## Proposal for a Supplement to the 06 series of amendments to Regulation No. 16 (Safety-belts)

Figure 2  
Installation of fixture onto vehicle seat  
(see paragraph 2.6.1.)

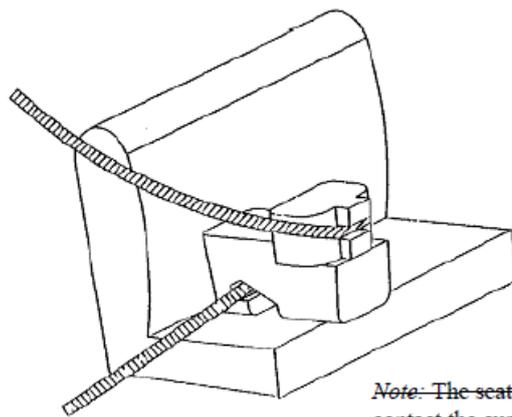
- 3.2. The lap portion of the belt shall touch the fixture on both sides at the rear of the lap belt path (see Figure 3). **The seat belt webbing shall contact the curved edge on both sides of the fixture over at least [50 %] of its width.**

~~Note: The seat belt webbing shall contact the curved edge on both sides of the fixture.~~
